# CITY OF ALBUQUERQUE

**Re: Apache Elementary – Kindergarden Addition, 12800 Copper Ave,  
Approval of Permanent Certificate of Occupancy (C.O.),  
Engineer's Stamp dated 12-01-08 (K-22/D003)  
Certification dated: 4-22-09**

**Re: Apache Elementary Kindergarten Addition Grading and Drainage Plan  
Engineer's Stamp dated 1-16-09 (K22/D003)**

**Re: Apache Elementary Kindergarten Addition Grading and Drainage Plan  
Engineer's Stamp dated 12-1-08 (K22/D003)**

FIELD CHANGE #1

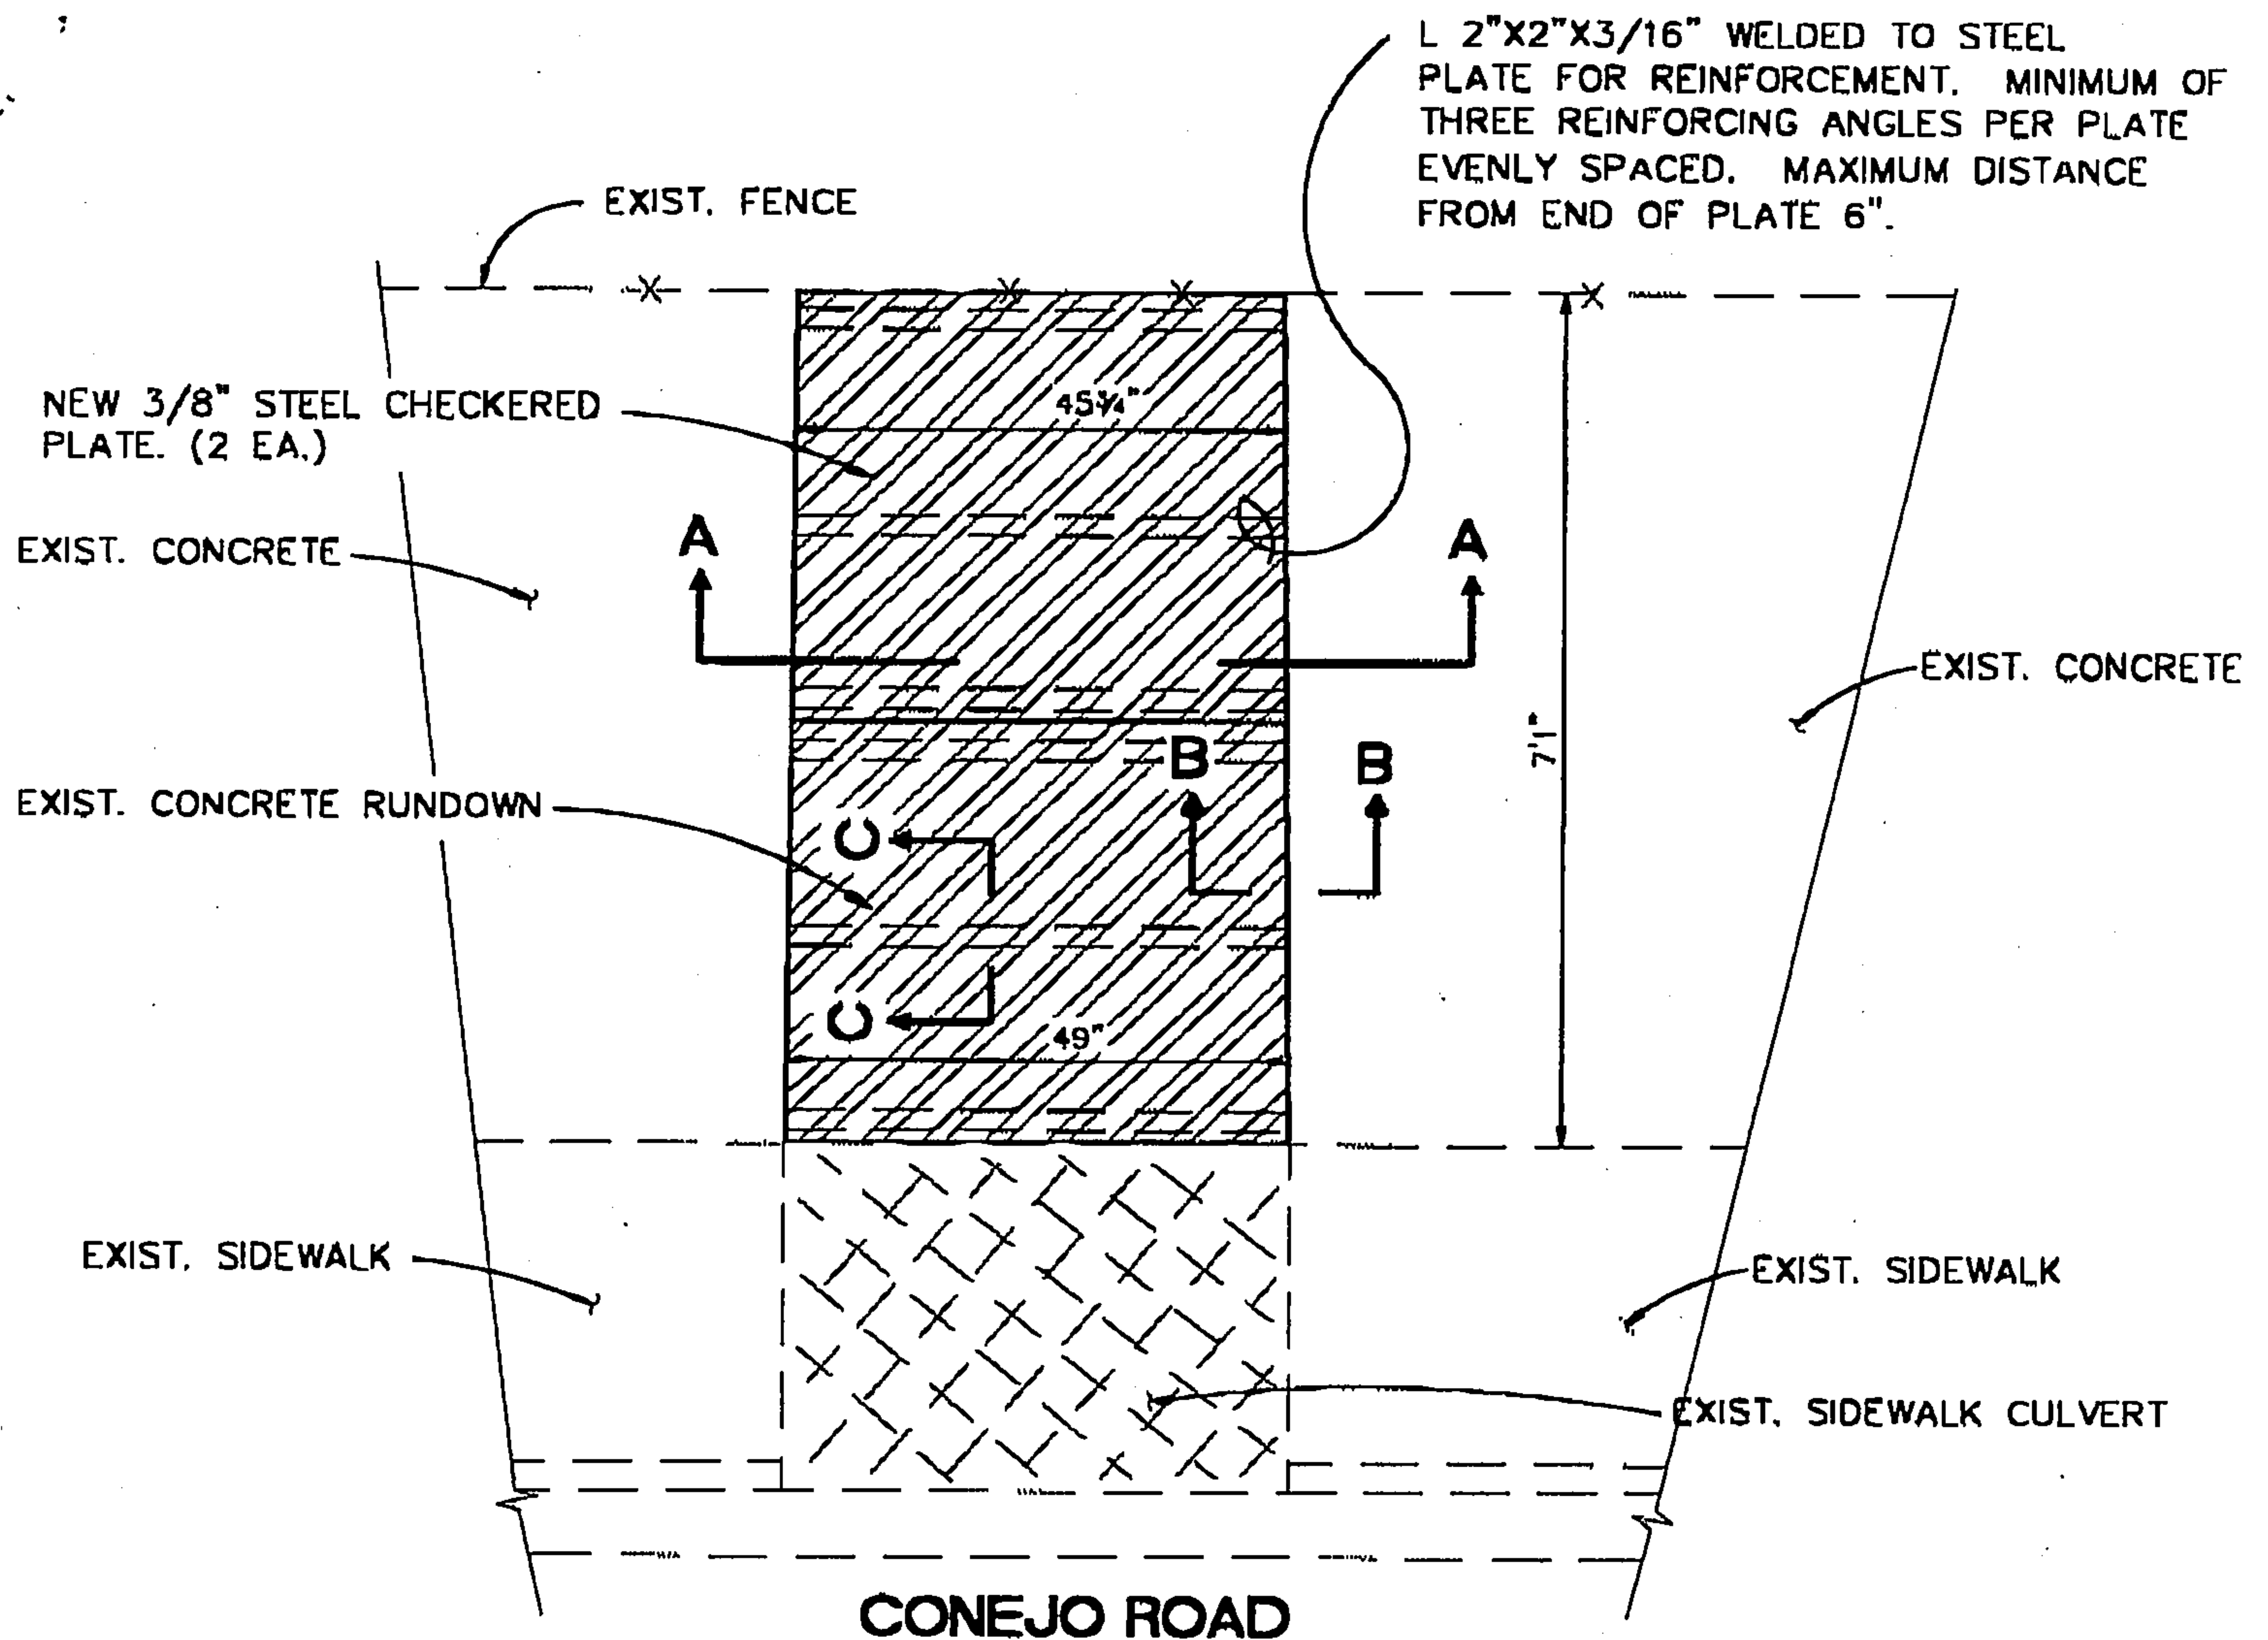
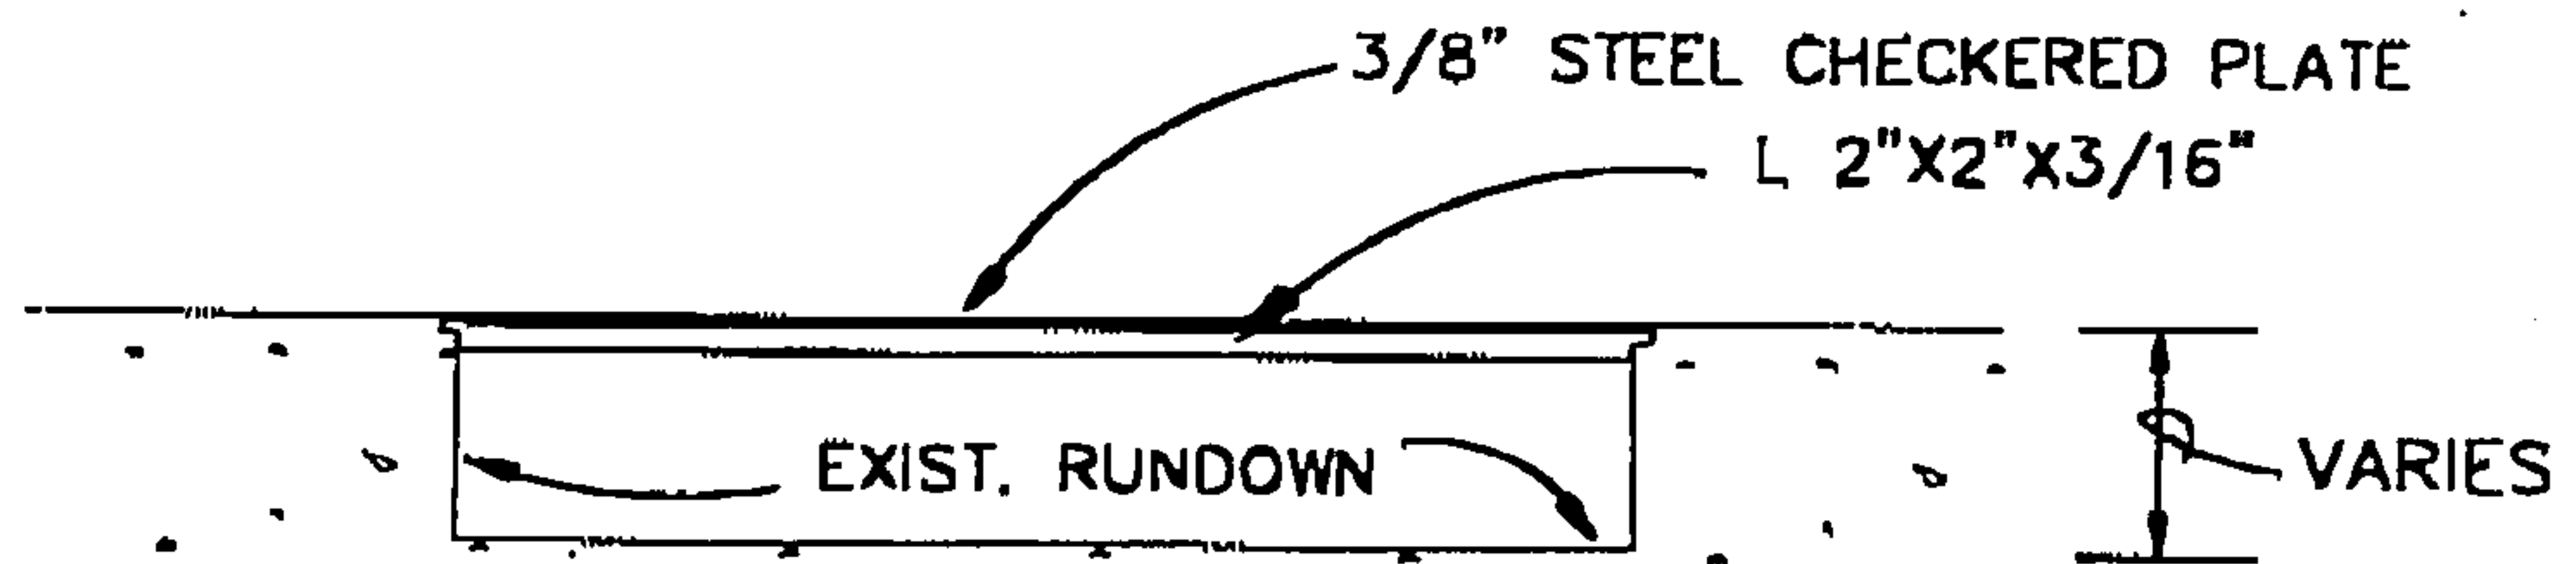
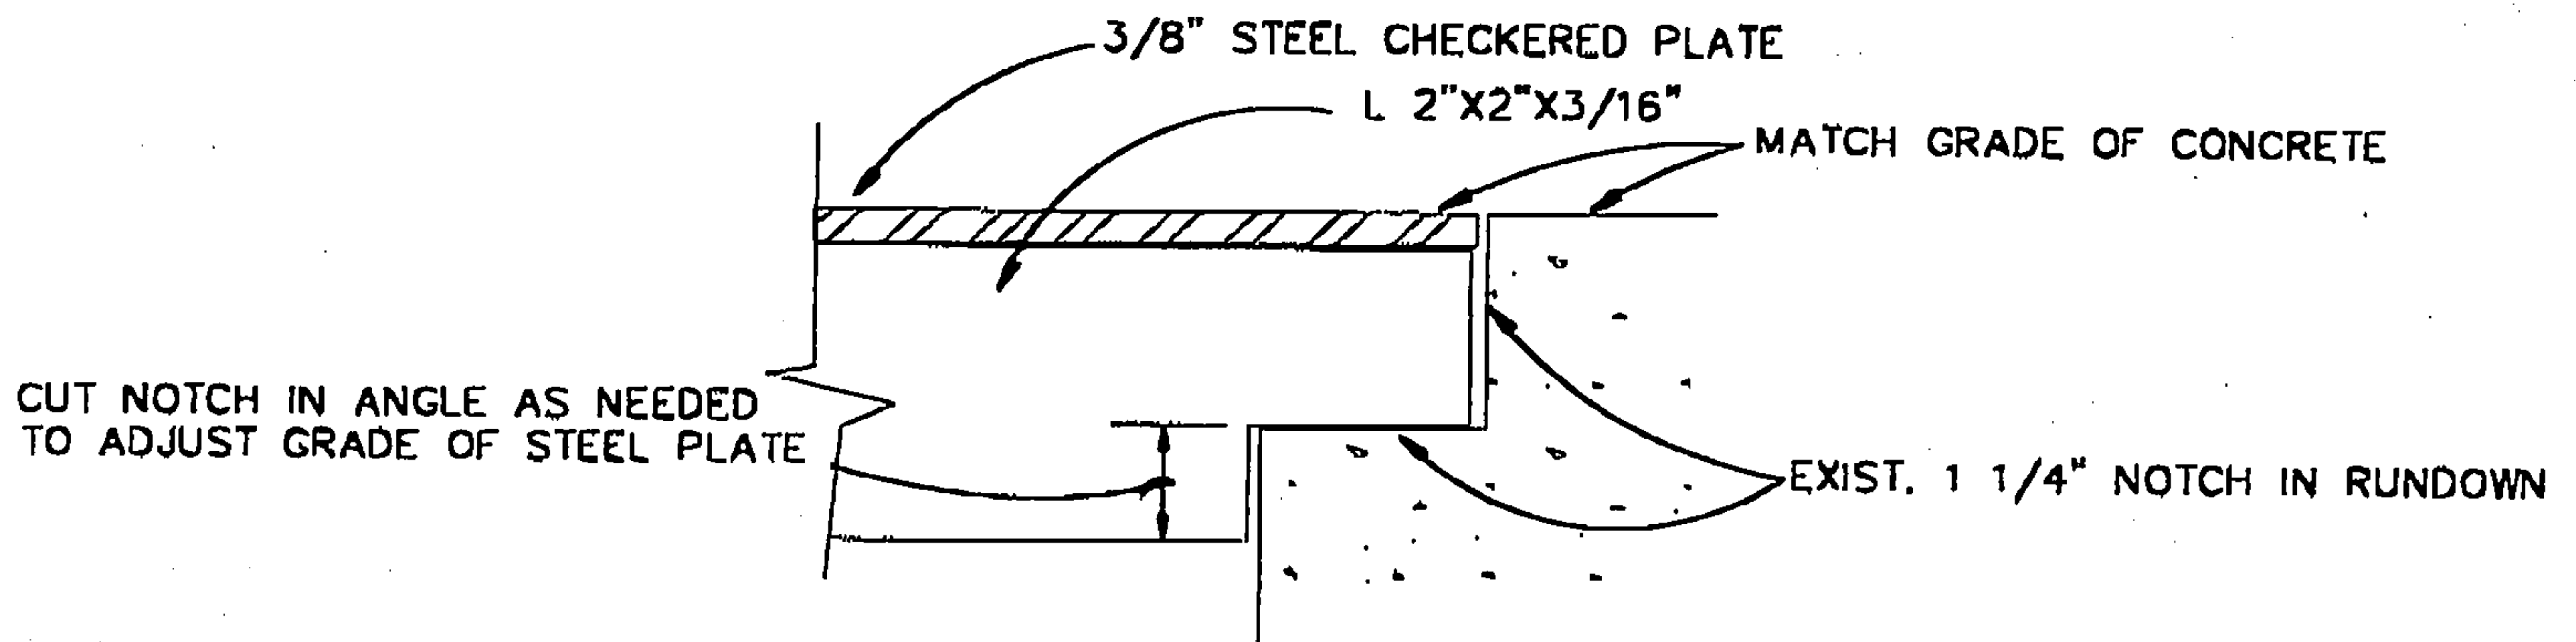
The run-down extends from the back of the sidewalk culvert approximately 7 feet to the fence at the boundary of the school. There is an existing fence opening inside of the run-down which the children use as access to the school. Mr. Lukins' concern is as follows:

1. A safety concern may exist with the 7 feet of open rundown;

- 1 USE TWO STEEL PLATES TO COVER RUNDOWN. EACH PLATE SHALL COVER HALF OF THE RUNDOWN.
- 2 THE NEW STEEL PLATE AND FRAME MEMBERS SHALL BE PAINTED PER COA STD. DWG. #2236.
- 3 THE NEW STEEL PLATE SHALL BE ANCHORED TO CONCRETE AS SHOWN IN SECTION B-B OF COA STD. DWG. #2236.
- 4 THIS DRAWING ADDRESSES THE RUNDOWN COVER ONLY. THE CONTRACTOR SHALL COORDINATE WITH THE COA STREET MAINTENANCE DIVISION TO DETERMINE THE EXTENT OF THE WORK ON THIS SIDEWALK CULVERT NECESSARY TO BE APPROVED FOR OCCUPANCY.
